ACCESSIBILITY ASSESSMENT

July 19, 2021

ADA TITLE II ASSESSMENT

Cottage City Towers
4142 Bunker Hill Road
Cottage City, Maryland 20722

Map for Barrier ID: AX240428

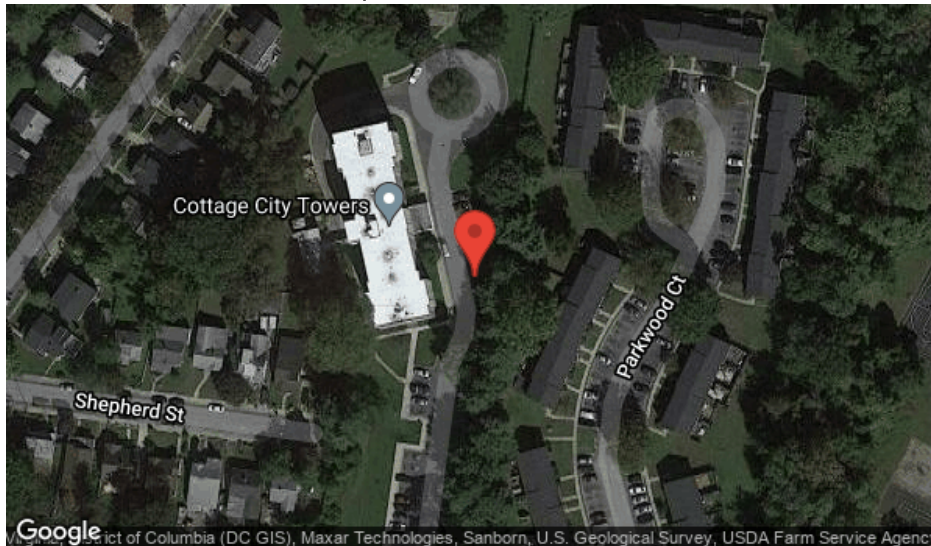
Assembly	Exterior Access Route
Type	Exterior Accessible Route
ADA Standard	403.3
Barrier Detail	The accessible route has cross slopes greater than 1:50 (2%).
Location Description	Curb Ramp CR1 to Curb Ramp CR2
Observed	May 17, 2021 by Ouraccessibleworld@gmail.com

The accessible route has cross slopes of up to 8.9% for a distance of approximately 85' by 5' wide.

The walkway should be graded to a maximum 1:50 (2%) cross slope. An accessible route has maximum 1:20 (5%) running slope and maximum 1:50 (2%) cross slope. [EXCEPTION: Cross slopes not exceeding 1:48 (2.08%) are permitted.] The clear width of walking surfaces shall be 36" minimum. [EXCEPTION: The clear width shall be permitted to be reduced to 32" minimum for a length of 24" maximum provided that reduced width segments are separated by segments that are 48" long minimum and 36" wide minimum.] Where grading to maximum running slope of 1:20 (5% running slope) is not possible, provide a compliant ramped surface within the walkway with maximum slope 1:12 (8.33%) and maximum ramp run rise of 6" without handrails. If a ramped surface with running slopes greater than 1:20 (5%) and maximum 1:12 (8.33%) rises more than 6", handrails are required. The cost estimate for this barrier removal is based on grading the running slope to maximum 1:20 (5%). The quantity and order of magnitude cost estimate provided for this barrier are limited to the extent of the area identified as non-compliant. Additional costs that may be associated with removal of the barrier are not included.

Map for Barrier ID: AX240431

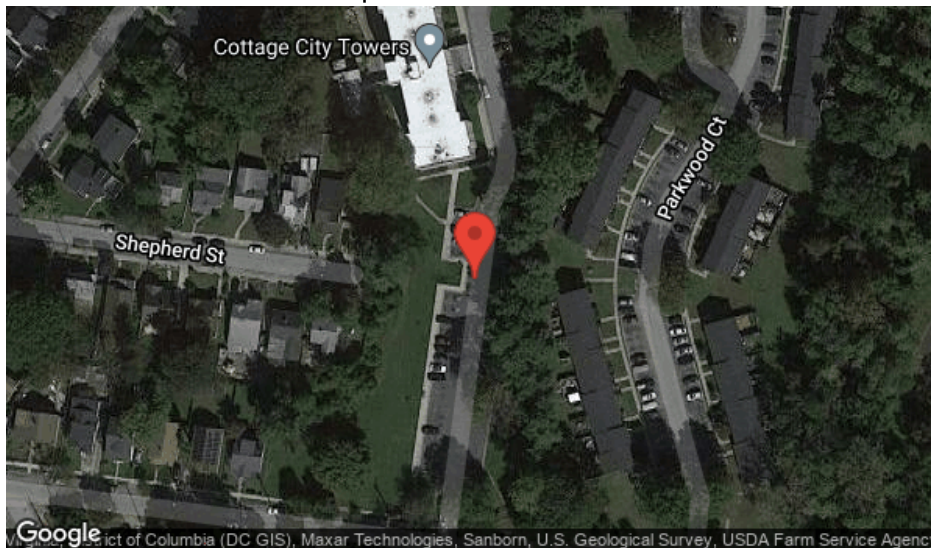
Assembly	Exterior Access Route
Type	Exterior Accessible Route
ADA Standard	403.3
Barrier Detail	The accessible route has cross slopes greater than 1:50 (2%).
Location Description	Curb Ramp CR3 to Curb Ramp CR4
Observed	May 17, 2021 by Ouraccessibleworld@gmail.com

The accessible route has cross slopes of up to 4.3% for a distance of approximately 70' by 4' wide.

The walkway should be graded to a maximum 1:50 (2%) cross slope. An accessible route has maximum 1:20 (5%) running slope and maximum 1:50 (2%) cross slope. [EXCEPTION: Cross slopes not exceeding 1:48 (2.08%) are permitted.] The clear width of walking surfaces shall be 36" minimum. [EXCEPTION: The clear width shall be permitted to be reduced to 32" minimum for a length of 24" maximum provided that reduced width segments are separated by segments that are 48" long minimum and 36" wide minimum.] Where grading to maximum running slope of 1:20 (5% running slope) is not possible, provide a compliant ramped surface within the walkway with maximum slope 1:12 (8.33%) and maximum ramp run rise of 6" without handrails. If a ramped surface with running slopes greater than 1:20 (5%) and maximum 1:12 (8.33%) rises more than 6", handrails are required. The cost estimate for this barrier removal is based on grading the running slope to maximum 1:20 (5%). The quantity and order of magnitude cost estimate provided for this barrier are limited to the extent of the area identified as non-compliant. Additional costs that may be associated with removal of the barrier are not included.

Map for Barrier ID: AX240432

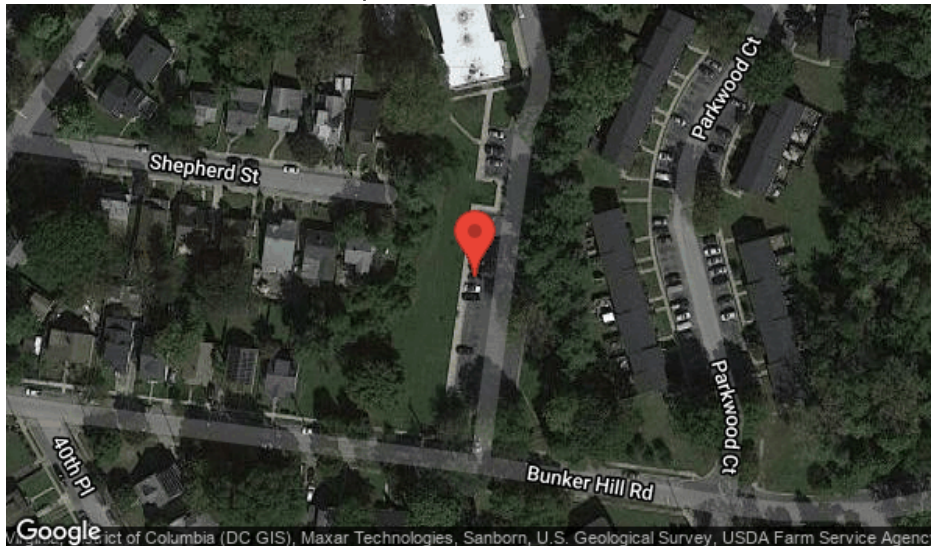
Assembly	Exterior Access Route
Type	Exterior Accessible Route
ADA Standard	403.3
Barrier Detail	The accessible route has cross slopes greater than 1:50 (2%).
Location Description	Curb Ramp CR4 to Street
Observed	May 17, 2021 by Ouraccessibleworld@gmail.com

The accessible route has cross slopes of up to 4.9% for a distance of approximately 240' by 5' wide.

The walkway should be graded to a maximum 1:50 (2%) cross slope. An accessible route has maximum 1:20 (5%) running slope and maximum 1:50 (2%) cross slope. [EXCEPTION: Cross slopes not exceeding 1:48 (2.08%) are permitted.] The clear width of walking surfaces shall be 36" minimum. [EXCEPTION: The clear width shall be permitted to be reduced to 32" minimum for a length of 24" maximum provided that reduced width segments are separated by segments that are 48" long minimum and 36" wide minimum.] Where grading to maximum running slope of 1:20 (5% running slope) is not possible, provide a compliant ramped surface within the walkway with maximum slope 1:12 (8.33%) and maximum ramp run rise of 6" without handrails. If a ramped surface with running slopes greater than 1:20 (5%) and maximum 1:12 (8.33%) rises more than 6", handrails are required. The cost estimate for this barrier removal is based on grading the running slope to maximum 1:20 (5%). The quantity and order of magnitude cost estimate provided for this barrier are limited to the extent of the area identified as non-compliant. Additional costs that may be associated with removal of the barrier are not included.

Photos for Barrier ID: AX240389

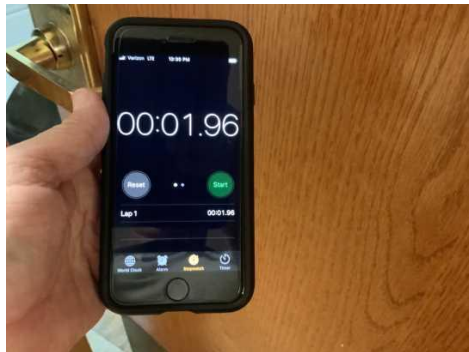
The accessible door with door closer has a sweep period of less than 5 seconds from 90 degrees to a position 12 degrees from latch and the opening force required to open the accessible, hinged, non-fire door is more than 5 pounds.

The door to the laundry requires up to 17 pounds of force to operate and has a closing g speed of up to 1.96 seconds from 90 degrees to a position 12 degrees from latch.

Adjust closer or remove and replace closer to ensure that the door has a closure time of at least 5 seconds within 12 degrees of the latch and that requires no more than 5 pounds of force for pushing or pulling the door open. Door closers and gate closers shall be adjusted so that from an open position of 90 degrees, the time required to move the door to a position of 12 degrees from the latch is 5 seconds minimum. The force at the latch, the force to set the door in motion, and the force to fully open the door shall be maximum 5 pounds. These forces do not apply to the force required to retract latch bolts or disengage other devices that hold the door or gate in a closed position.

Map for Barrier ID: AX240398

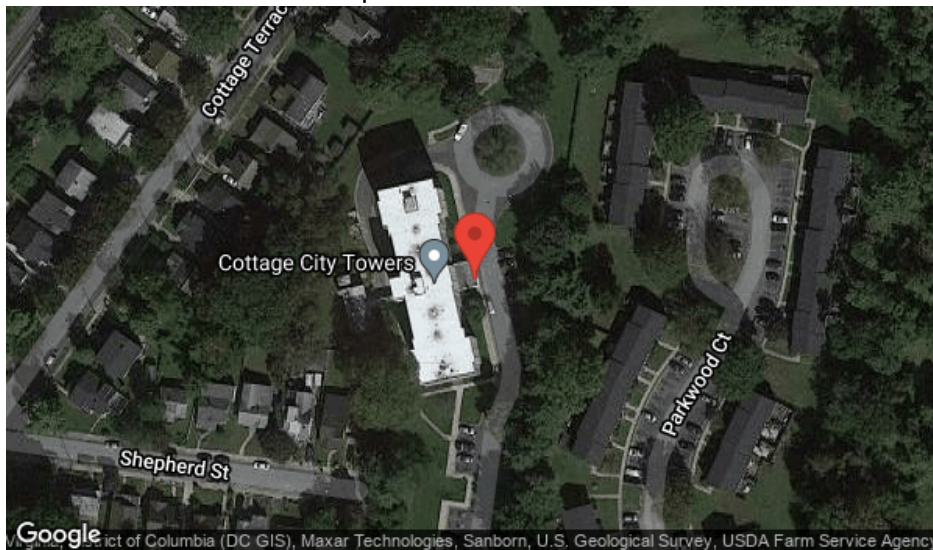
Assembly	Entrance to Building
Type	Building Entrance-Door
ADA Standard	305.2; 404.2
Barrier Detail	The maneuvering clearance at the accessible door is not level and clear.
Location Description	Main Entrance
Observed	May 17, 2021 by Ouraccessibleworld@gmail.com

For a front approach on the pull side the maneuvering clearance has a running slope of up to 4.0%.

Remove and replace the surface within the required maneuvering clearance area so that the surface is level and clear with maximum slope 1:48 (2.08%) in any direction. This barrier must be removed in conjunction with barrier ID 240399. The required depth of the maneuvering clearance is 60" minimum. The required side clearance is 18" minimum on the latch side of the door. Maneuvering clearance shall extend the full width of the doorway and the required latch side clearance. Floor or ground space within the required maneuvering clearance shall be maximum 1:48 (2.08%) slope. Changes in level are not permitted.

Photos for Barrier ID: AX240399

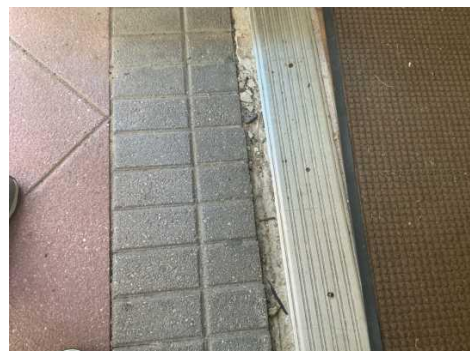
Assembly	Exterior Access Route
Type	Exterior Accessible Route
ADA Standard	302.3
Barrier Detail	The accessible route has gaps in the surface greater than 1/2" wide.
Location Description	Main Entrance
Observed	May 17, 2021 by Ouraccessibleworld@gmail.com
Site Conditions	The threshold area at the main entrance has a gap of up to 2" wide.

Repair the accessible route to eliminate openings in the surface greater than 1/2" wide. This barrier must be removed in conjunction with barrier ID 240398. The cost of this barrier removal is covered under ID 240398 and therefore, the cost of this ID is shown as \$0. Openings in the ground surface of the accessible route shall not allow passage of a sphere more than 1/2" diameter. Elongated openings shall be placed so that the long dimension is perpendicular to the dominant direction of travel.

Map for Barrier ID: AX240396

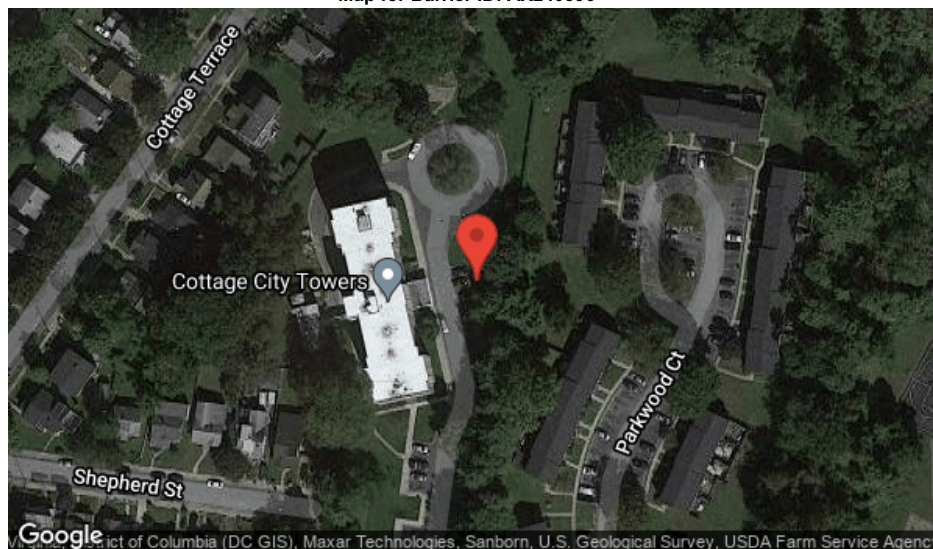
Assembly	Accessible Parking
Type	Parking Space-Car
ADA Standard	502.3; 502.4; 502.5
Barrier Detail	An access aisle is not provided.
Location Description	Parking Lot
Observed	May 17, 2021 by Ouraccessibleworld@gmail.com

There are 4 accessible spaces located at the main entrance. None of the accessible spaces have an access aisle provided. Two standard and one van access aisle is required.

Re-stripe and add an adjacent access aisle that is at least 60" wide and has a slope of maximum 1:48 (2.08%) in all directions. Width measurements shall be made from the centerline of the markings. [EXCEPTION: Where parking spaces or access aisles are not adjacent to another parking space or access aisle, measurements shall be permitted to include the full width of the line defining the parking space or access aisle.] Access aisles shall adjoin an accessible route. Two parking spaces shall be permitted to share a common access aisle. Accessible routes must connect parking spaces to accessible entrances. In parking facilities where the accessible route must cross vehicular traffic lanes, marked crossings enhance pedestrian safety, particularly for people using wheelchairs and other mobility aids. Where possible, it is preferable that the accessible route not pass behind parked vehicles. Access aisles serving car and van parking spaces shall be 60" wide minimum. Access aisles shall extend the full length of the parking spaces they serve. Access aisles shall be marked so as to discourage parking in them. Access aisles shall not overlap the vehicular way. Access aisles shall be permitted to be placed on either side of the parking space except for angled van parking spaces which shall have access aisles located on the passenger side of the parking spaces. Access aisles shall be at the same level as the parking spaces they serve. Changes in level are not permitted. [EXCEPTION: Slopes not steeper than 1:48 shall be permitted.] Access aisles are required to be nearly level in all directions to provide a surface for wheelchair transfer to and from vehicles. The exception allows sufficient slope for drainage. Built-up curb ramps are not permitted to project into access aisles and parking spaces because they would create slopes greater than 1:48. Parking spaces for vans and access aisles and vehicular routes serving them shall provide a vertical clearance of 98" minimum. Width measurements of parking spaces and access aisles shall be made from the centerline of the markings. Where accessible stalls and aisles are not adjacent to accessible stalls and aisles, measurements shall be permitted to include the full width of the line defining the accessible parking space or aisle.

Figure 6
Side Reach

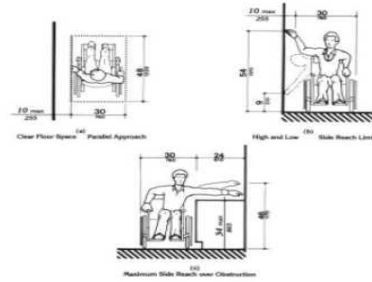
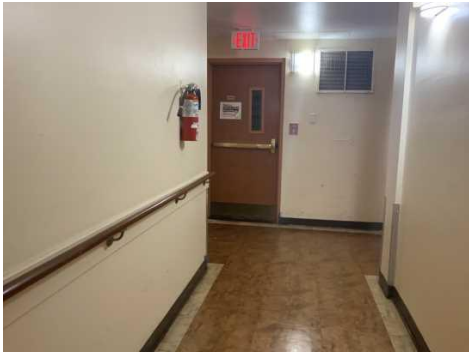
Elements that require a side reach motion are not within the allowable reach range.

Site Conditions	The fire extinguishers are mounted up to 64" above the floor surface.
------------------------	---

Locate the element within the allowable side reach range, measured from the finish floor or ground. If the clear floor space allows a parallel approach by a person in a wheelchair for an unobstructed side reach, the high side reach shall be maximum 54" and the low side reach shall be minimum 9" above the floor (Figures 6(a) and (b)). If the clear floor space allows a parallel approach by a person in a wheelchair and is obstructed, requiring an obstructed side reach, the obstructed high side reach shall be maximum 46" and maximum 24" horizontally over an obstruction maximum 34" in height. If the side reach is over an obstruction, the reach and clearances shall be as shown in Figure 6(c).

Photos for Barrier ID: AX240393

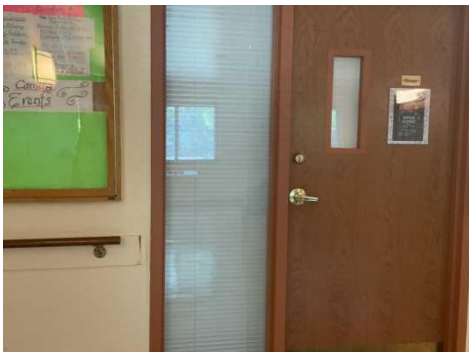
The existing signage is not mounted at the latch side of the door or at a compliant height.

The signage at the office is mounted on the door and does not have tactile characters.

Remove and remount signage alongside the latch side of the door mounted at compliant height. Tactile characters on signs shall be located 48" minimum above the finish floor or ground surface, measured from the baseline of the lowest tactile character and 60" maximum above the finish floor or ground surface, measured from the baseline of the highest tactile character. [EXCEPTION: Tactile characters for elevator car controls shall not be required to comply.] Where a tactile sign is provided at a door, the sign shall be located alongside the door at the latch side. Where a tactile sign is provided at double doors with one active leaf, the sign shall be located on the inactive leaf. Where a tactile sign is provided at double doors with two active leaves, the sign shall be located to the right of the right hand door. Where there is no wall space at the latch side of a single door or at the right side of double doors, signs shall be located on the nearest adjacent wall. Signs containing tactile characters shall be located so that a clear floor space of 18" minimum by 18" minimum, centered on the tactile characters, is provided beyond the arc of any door swing between the closed position and 45 degree open position [EXCEPTION: Signs with tactile characters shall be permitted on the push side of doors with closers and without hold-open devices.]

Map for Barrier ID: AX240400

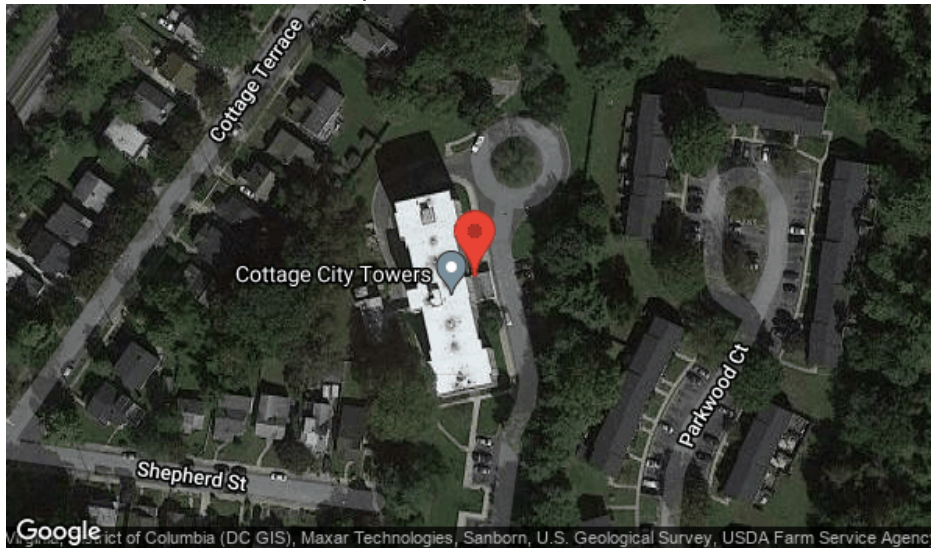
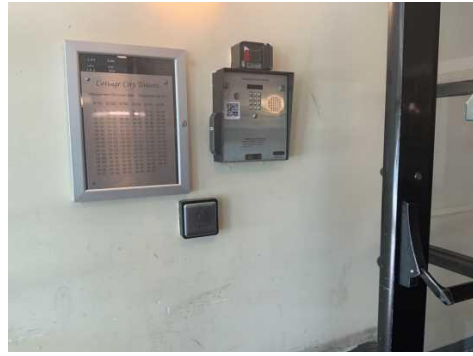
Operable parts or items requiring an unobstructed forward reach motion are higher than 48" maximum or lower than 15" minimum height above finish floor.

Site Conditions	The controls for the entry system are mounted up to 56" above the sidewalk.
------------------------	---

Relocate part to a compliant reach range. Where a forward reach is unobstructed, the high forward reach shall be 48" maximum and the low forward reach shall be 15" minimum above the finish floor or ground. Where the high forward reach is over an obstruction, the clear floor space shall extend beneath the element for a distance not less than the required reach depth over the obstruction. The high forward reach shall be 48" maximum where the reach depth is 20" maximum. Where the reach depth exceeds 20" , the high forward reach shall be 44" maximum and the reach depth shall be 25" maximum. [EXCEPTION: An obstruction shall be permitted between the clear floor or ground space and the element where the depth of the obstruction is 10" maximum.] [ADVISORY for Children's Forward or Side Reach Ranges: High reach (maximum): 36" for ages 3 to 4; 40" for ages 5 to 8; and 44" for ages 9 to 12. Low reach (minimum): 20" for ages 3 to 4; 18" for ages 5 to 8; and 16" for ages 9 to 12.]

Map for Barrier ID: AX240386

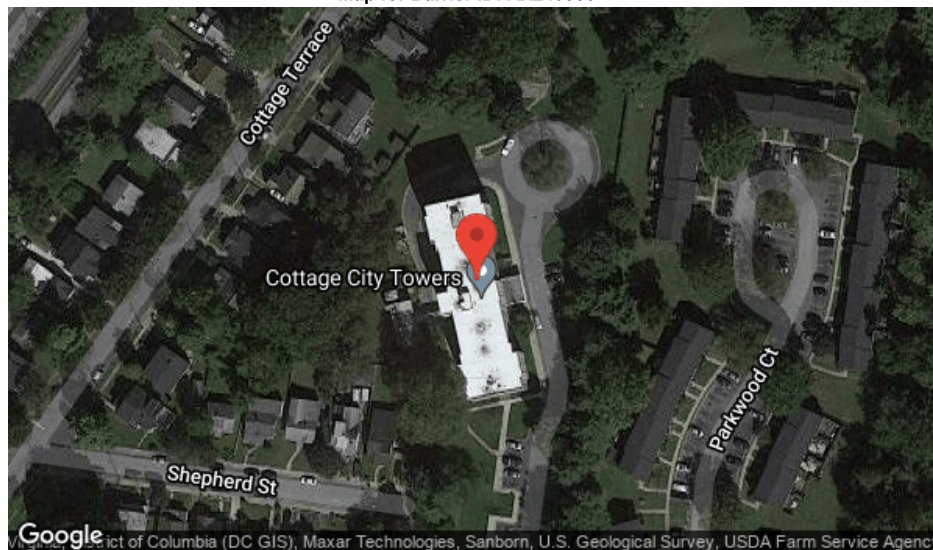
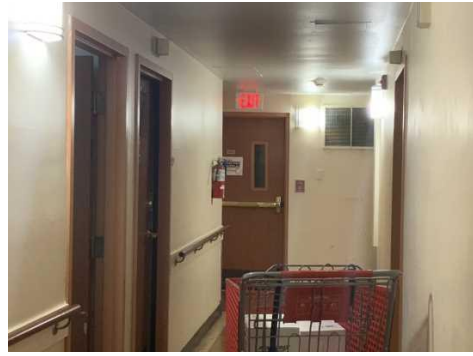
Assembly	Interior Access Route
Type	Signage
ADA Standard	216.4, 703.1, 703.4
Barrier Detail	Means of egress signage is not provided.
Location Description	Lobby
Observed	May 17, 2021 by Ouraccessibleworld@gmail.com
Site Conditions	Means of egress signage with tactile characters is not provided at the exits.

Provide compliant means of egress signage at each exit passageway, exit discharge, and exit stairway. Signs at designated egress passageways, stairways, exit doors and areas of refuge shall include tactile signage. Signs shall be installed alongside the door at the latch side. [EXCEPTION: Signs with tactile characters shall be permitted on the push side of doors with closers and without hold-open devices.] Where a tactile sign is provided at double doors with one active leaf, the sign shall be located on the inactive leaf. Where a tactile sign is provided at double doors with two active leaves, the sign shall be located to the right of the right hand door. Where there is no wall space at the latch side of a single door or at the right side of double doors, sign shall be located on the nearest adjacent wall. Where both visual and tactile characters are required, either one sign with both visual and tactile characters, or two separate signs, one with visual, and one with tactile characters, shall be provided. Signs containing tactile characters shall be located so that clear floor space of 18" minimum by 18" minimum, centered on the tactile characters, is provided beyond the arc of any door swing between the closed position and 45 degrees open. Raised characters shall be compliant and shall be duplicated in Braille. Raised characters shall be as follows- Depth: Raised characters shall be 1/32" minimum above their background. Case: Characters shall be uppercase. Style: Characters shall be sans serif. Characters shall not be italic, oblique, script, highly decorative, or of other unusual forms. Character Proportions: Characters shall be selected from fonts where the width of the uppercase letter "O" is 55% minimum and 110% maximum of the height of the uppercase letter "I". Character Height: Character height measured vertically from the baseline of the character shall be 5/8" minimum and 2" maximum based on the height of the uppercase letter "I". [EXCEPTION: Where separate raised and visual characters with the same information are provided, raised character height shall be permitted to be 1/2" minimum.]

Map for Barrier ID: AX240427

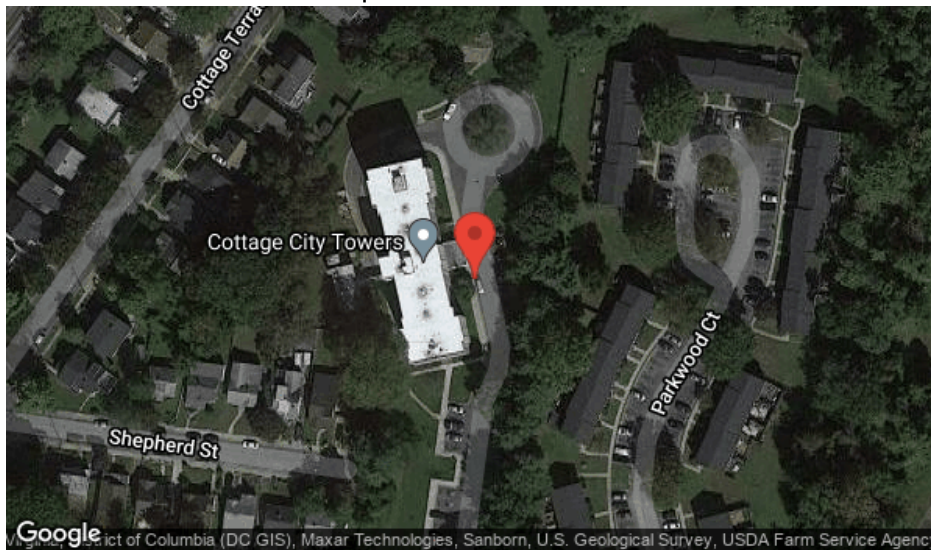
Assembly	Exterior Access Route
Type	Clear Space
ADA Standard	305; 309.2
Barrier Detail	Clear space is not provided at the operable part.
Location Description	Main Entrance
Observed	May 17, 2021 by Ouraccessibleworld@gmail.com
Site Conditions	The clear space at the mail box has slopes of up to 2.6%.
Resolution	
Provide clear space at the operable part. Floor or ground surfaces of a clear floor or ground space shall have slopes not steeper than 1:48, and shall be stable, firm, and slip resistant. Clear space shall be 30" minimum by 48" minimum, positioned for a forward or parallel approach. One full unobstructed side shall adjoin an accessible route or adjoin another clear floor or ground space. Clear floor or ground space shall include knee and toe clearance.	
Quantity	
12 SF	
Priority	3

Figure 29
Grab Bars at Water Closets

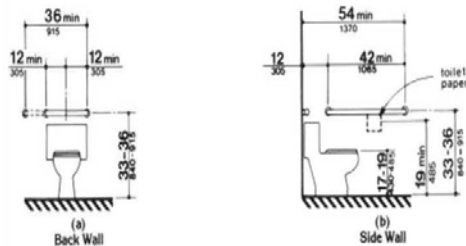
Assembly	Residential Dwelling
Type	Restroom/Bathroom-Water Closet
ADA Standard	UFAS 4.34.5.2 (4)
Barrier Detail	The toilet paper dispenser is not compliant.
Location Description	Unit 102
Observed	May 17, 2021 by Ouraccessibleworld@gmail.com
Site Conditions	The toilet paper dispenser is mounted 39" to the far edge from the rear wall.

Relocate the toilet paper dispenser. The toilet paper dispenser shall be mounted within reach at a minimum height of 19" to the centerline of the toilet paper roll. An adaptable toilet paper dispenser shall be maximum 36" from the rear wall at the water closet to the far edge of the toilet paper roll. Dispensers that control delivery, or that do not permit continuous paper flow, shall not be used.

Figure 28
Clear Floor Space at Water Closets

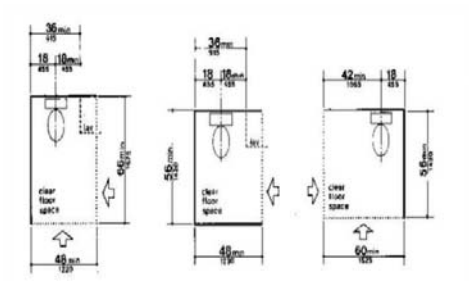
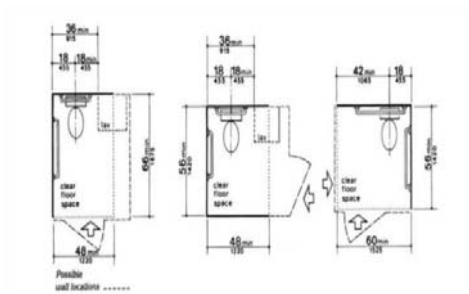
Assembly	Residential Dwelling
Type	Restroom/Bathroom-Water Closet
ADA Standard	UFAS 4.16.2, Fig. 28, 4.34.5.2(1); Fig. 47(a)
Barrier Detail	The centerline of the water closet is not exactly 18" from the side wall.
Location Description	Unit 107,110, 511, 603
Observed	May 17, 2021 by Ouraccessibleworld@gmail.com
Site Conditions	The centerline of the water closet is 18-1/4" to 19" from the side wall.
Resolution	Relocate the centerline of the water closet so that it is exactly 18" from the side wall. Clear floor space at the water closet shall be as shown in Figure 28, and Figure 47(a) for adaptable units. The water closet may be located with the clear area at either the right or left side of the toilet.
Quantity	4 EA
Priority	3
